Subject: Three Mile Island Nuclear Generating Station, Unit 1 (TMI-1)
Operating License No. DPR-50
Docket No. 50-289
Response to Request for Additional Information - Core Reload
Methodology

NRC letter dated August 23, 1995 requested additional information regarding GPU Nuclear Topical Report TR-091, Revision 0, "Steady State Reactor Physics Methodology for TMI-1." This Topical Report was submitted by GPU Nuclear on March 6, 1995 for NRC review and approval for in-house GPU Nuclear core reload design.

Figure 1 Power Imbalance Alarm Limits
(0-to-75 EFPD and 4 Pump Operation)

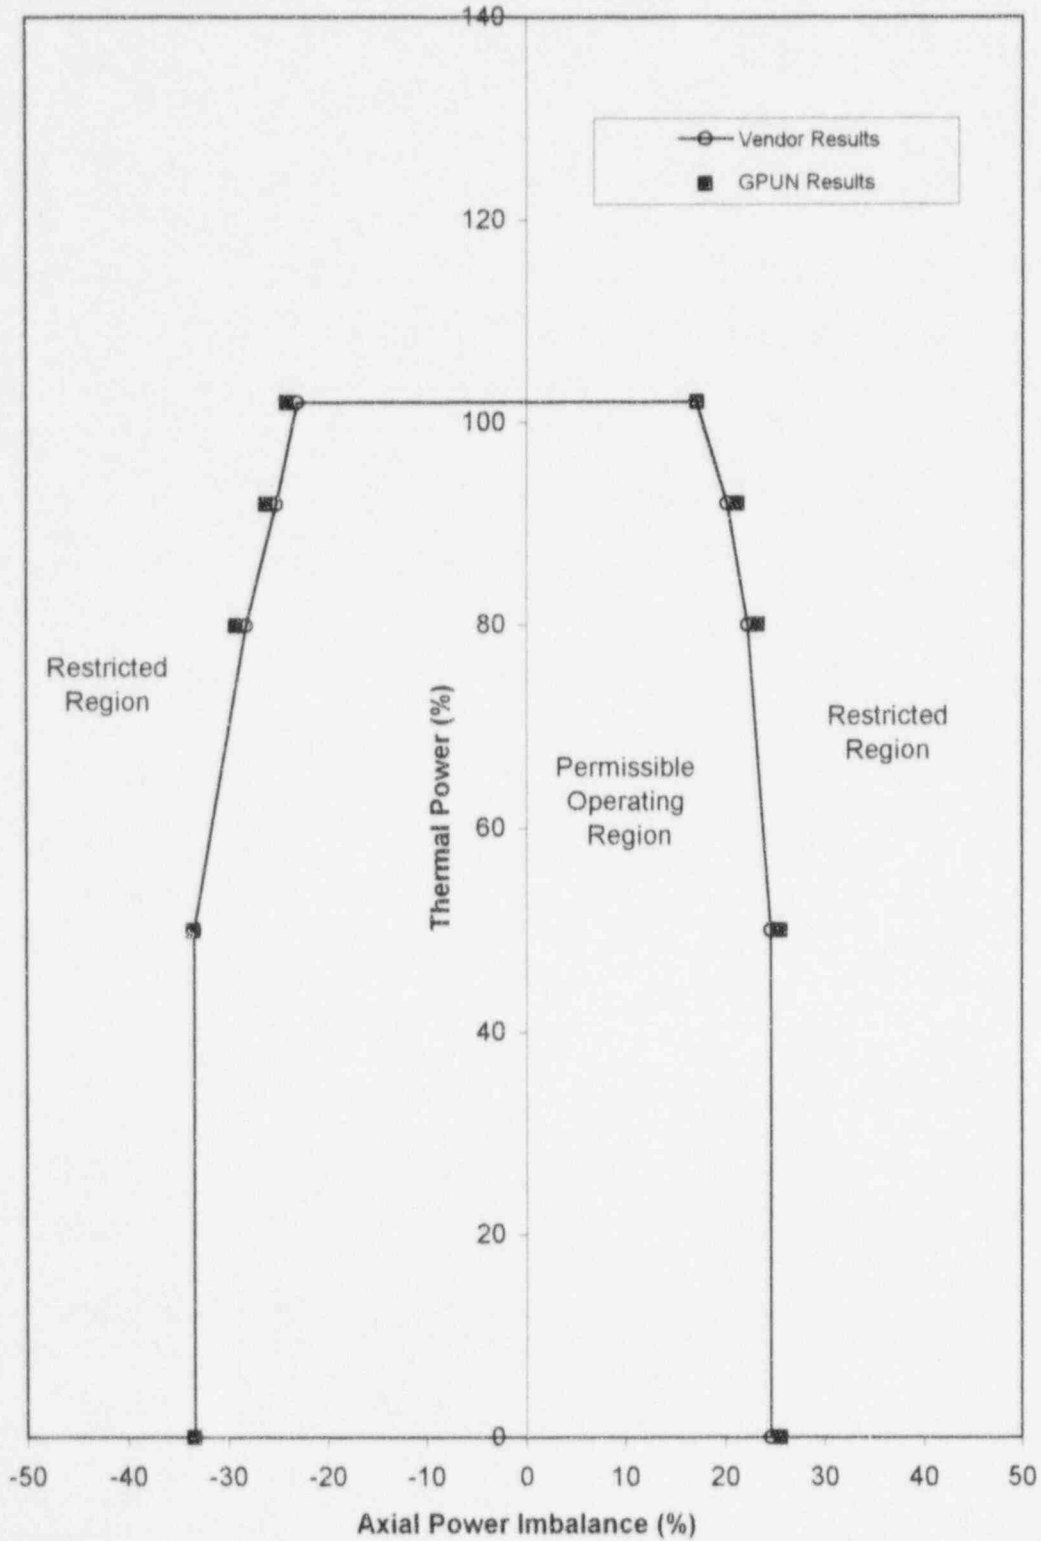
4. What effect will the use of these new reliability factors have on existing plant operating limits?

Since the reliability factors determined in TR-091 are either the same or close to the current values (see answers to Questions 2 and 3), the impact of using the new reliability factors on existing plant operating limits is insignificant. As shown in the attached Figures 1 and 2, the power imbalance alarm limits and control rod insertion limits generated with GPU Nuclear methodology are essentially the same as the
